SUBJECT: Comments on “DRAFT REPORT - Dam Safety Assessment of CCW Impoundments: TVA Johnsonville Fossil Plant”

Re: Response to Recommendations
USEPA CCR Impoundment Assessment DRAFT Report
Johnsonville Fossil Plant (JOF)
New Johnsonville, Tennessee

TENNESSEE VALLEY AUTHORITY (TVA) – COMMENTS ON COAL ASH SITE ASSESSMENT
ROUND 11 DRAFT REPORTS FOR ALLEN (ALF), BULL RUN, (BRF) COLBERT (COF),
CUMBERLAND (CUF), GALLATIN (GAF), JOHN SEVIER (JSF), JOHNSONVILLE, (JOF)
KINGSTON (KIF), PARADISE (PAF), SHAWNEE (SHF), WATTS BAR (WBF), AND WIDOWS
CREEK (WOF) FOSSIL PLANTS

Section K - Ash Disposal Area 2
Johnsonville Fossil Plant
New Johnsonville, Tennessee

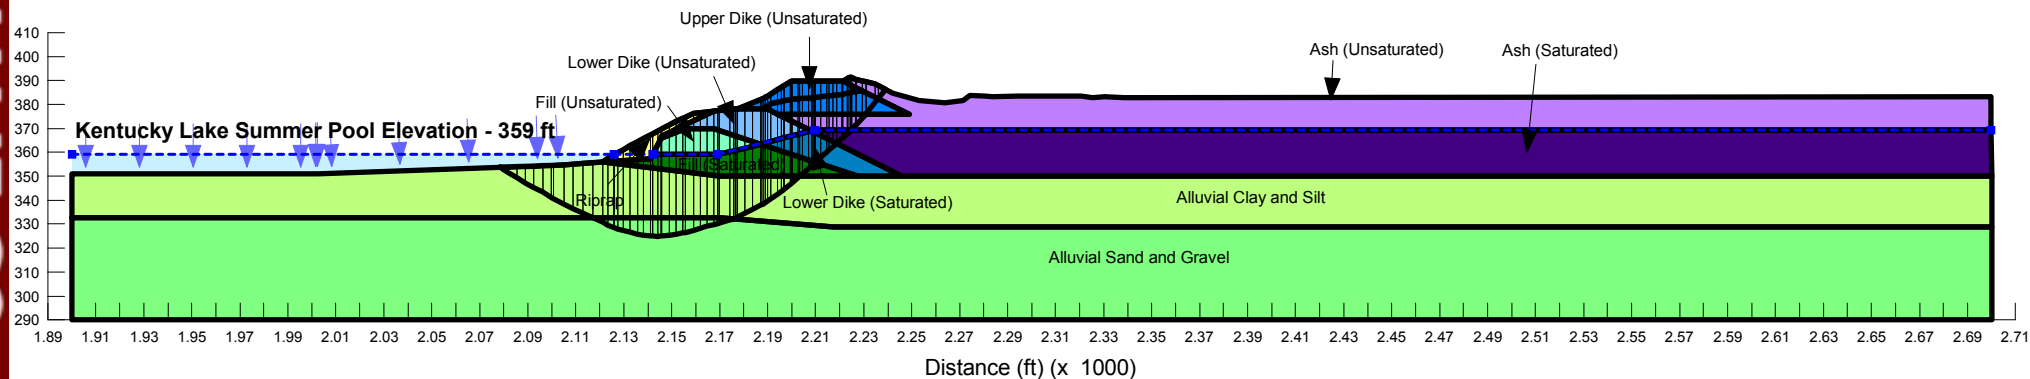
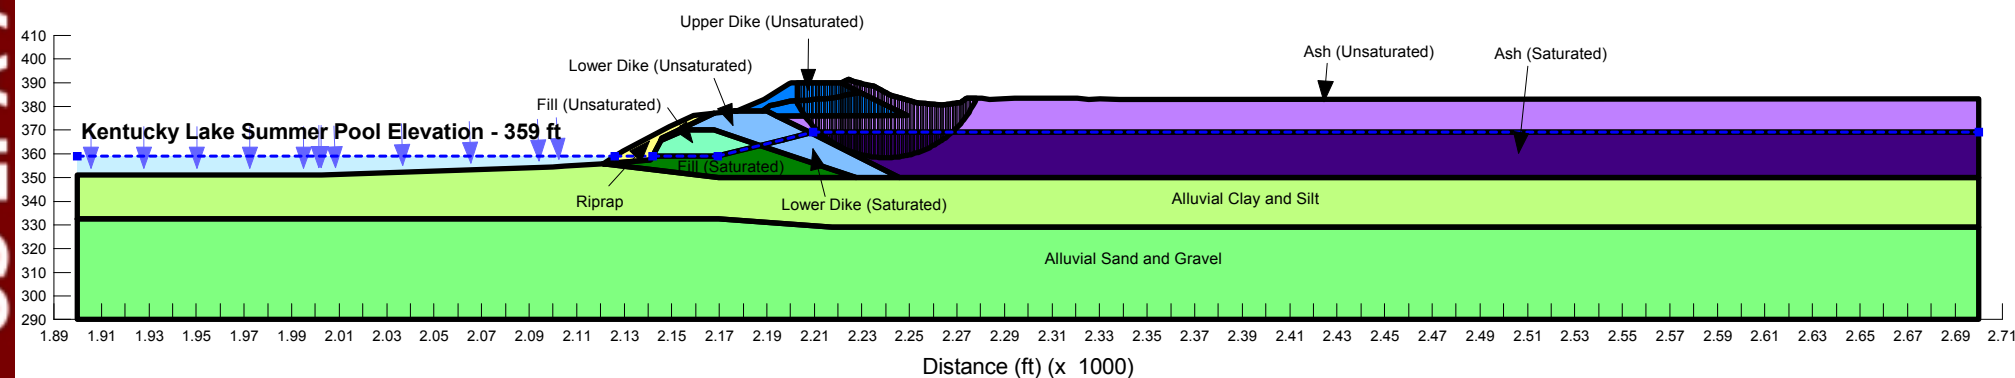
Dewberry Report Section 1.2.3 2): If liquefaction is indicated by the analysis, perform a post-earthquake analysis using static slope stability analysis using reduced shear strengths.

Stantec Response: Based on the results of the liquefaction potential assessment, residual strengths were assigned to the liquefied materials and post-earthquake static stability analysis was performed for Section K. A description of the methodology and the results (slope stability cross section, including table of material parameters) are attached. The results indicate that Section K has a factor of safety greater than or equal to the target threshold value of 1.0; thus, the slope is judged to remain stable and will not undergo significant liquefaction-induced deformations due to the 2,500-year earthquake.
